NOTICE OF MEETING
HILLSIDE REVIEW BOARD
CITY OF ST. GEORGE
WASHINGTON COUNTY, UTAH

HILLSIDE REVIEW BOARD AGENDA REPORT: 11/18/2013

HILLSIDE DEVELOPMENT PERMIT: Case No. 2015-HS-003

Jones Family Hill - Removal

Photos (Saturday 11/7/2015)

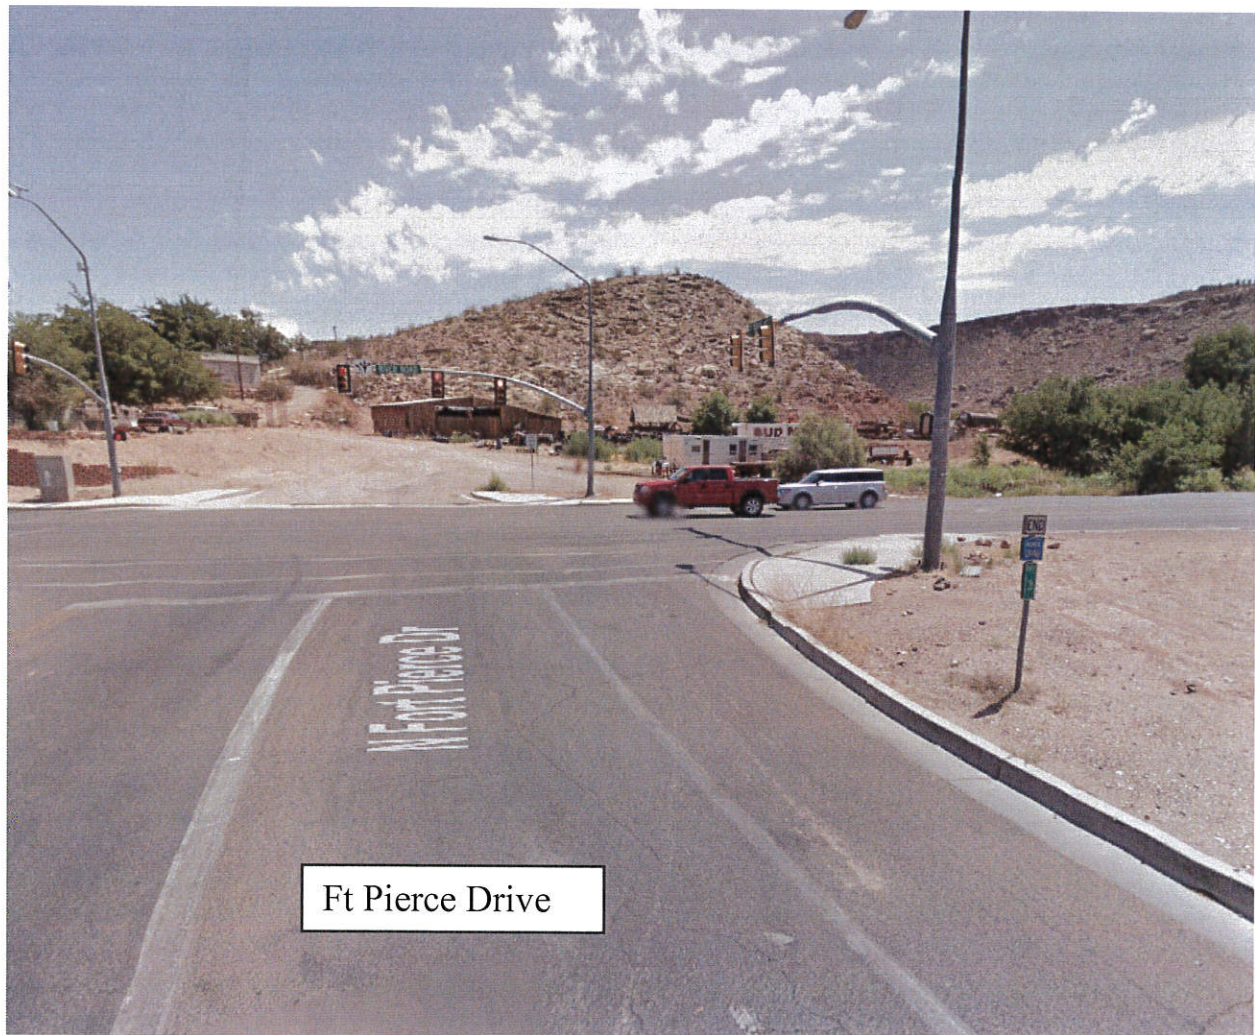
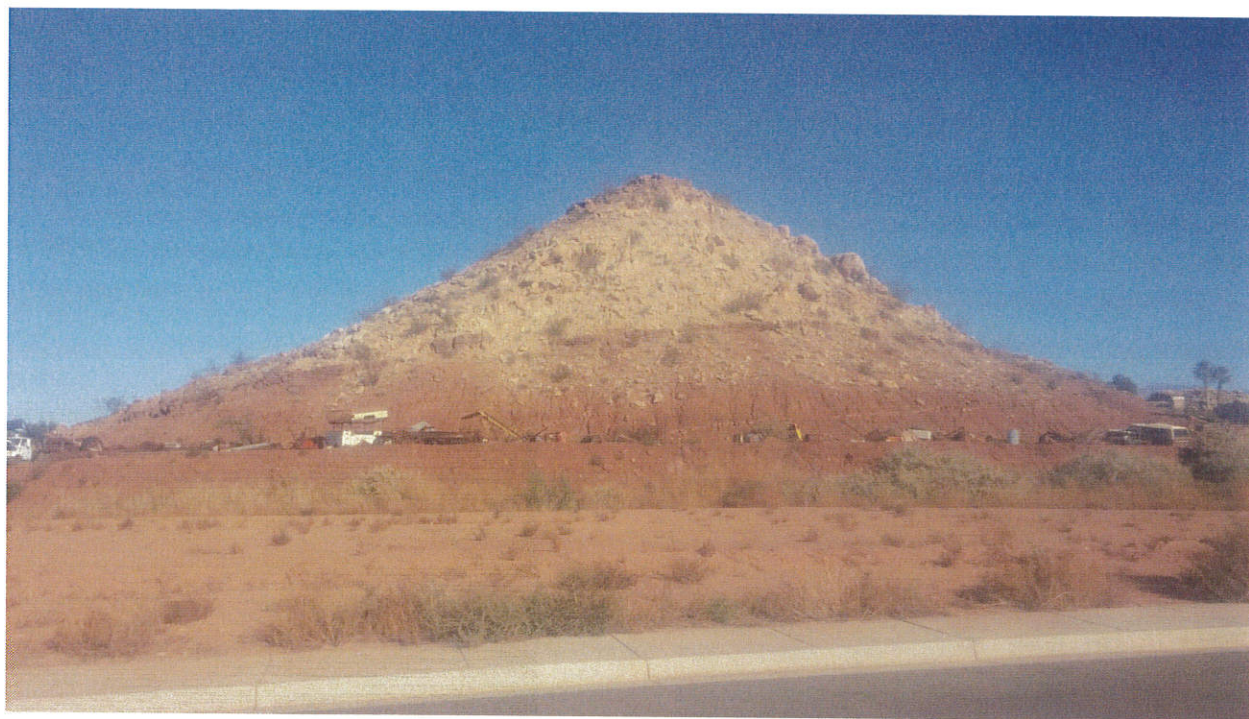
Comments: This area includes a complete hill which the applicant wants to be considered as non-contiguous to any significant outcroppings for single family site development. Due to the request, several of the requirements typically required was not submitted, given any engineering would not be applicable if the hill was removed. If the board determines that the hillside is not significant, staff recommends the hill be removed to a

similar elevation to River Road. This will prevent development being terraced up the hillside or the creation of view lots.
